Access Compliance Report

Public Rights-of-Way

(Curb Ramps)

Intersection ID: 25199	Main Street: DONNEGAL_FARM_RD	Cross Street: BRIDLE_BROOK_WY	Location:	N
ADA ID: E1627A9FB2D6	Ramp Type: Perp	Initial Pass/Fail: Fail	Overall Compliance: No	Severity Score: 25
Codes/Mitigation Info/Possible Solution		Field Measurements/Component Compliance

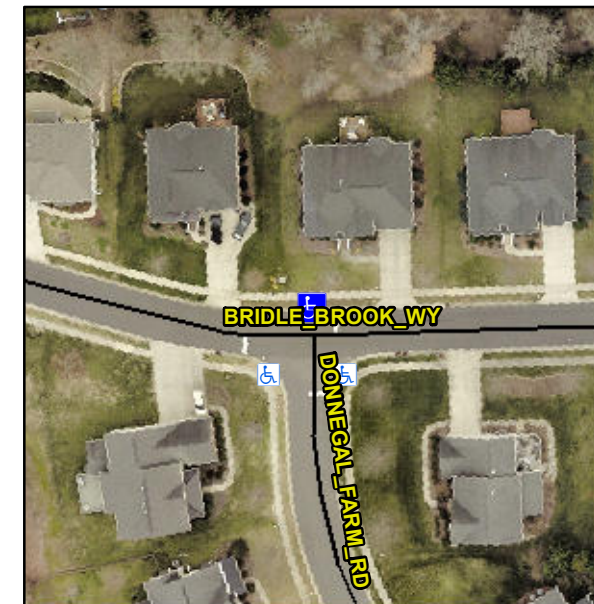
Not Found, R304.2.2, R304.5.3

Compliance	Description	Data	Compliance	Description	Data
N/A	Ramp Length (in)	47.0	No	Ramp Slope (%)	9.9
Yes	Ramp Width (in)	48.0	No	Ramp XSlope (%)	5.8
N/A	Flare Type LT	N/A	N/A	Flare Type RT	N/A
N/A	Flare Slope LT (%)	N/A	N/A	Flare Slope RT (%)	N/A
N/A	Flare Traversable LT?	N/A	N/A	Flare Traversable RT?	N/A
N/A	Landing Length (in)	N/A	N/A	DWS Provided?	N/A
N/A	Landing Width (in)	N/A	N/A	DWS Contrast?	N/A
N/A	Landing Slope (%)	N/A	N/A	DWS Length (in)	N/A
N/A	Landing X Slope (%)	N/A	N/A	DWS Full Width?	N/A
N/A	Landing Curb? (Y/N)	N/A	N/A	DWS Offset (in)	N/A
N/A	Shared Landing?	N/A			
N/A	Gutter Ponding?	N/A	N/A	Gutter Slope (%)	N/A
N/A	Gutter Lip Ht (in)	N/A	N/A	Gutter X Slope (%)	N/A
N/A	Painted X Walk1?	No	N/A	Painted X Walk2?	N/A
	X Walk 1 Direction	To SE		X Walk 2 Direction	N/A
N/A	X Walk 1 Width (in)	N/A	N/A	X Walk 2 Width (in)	N/A
	X Walk 1 Slope (%)	4.3		X Walk 2 Slope (%)	N/A
	X Walk 1 X Slope (%)	6.1		X Walk 2 X Slope (%)	N/A

Remove & Replace Entire Ramp.
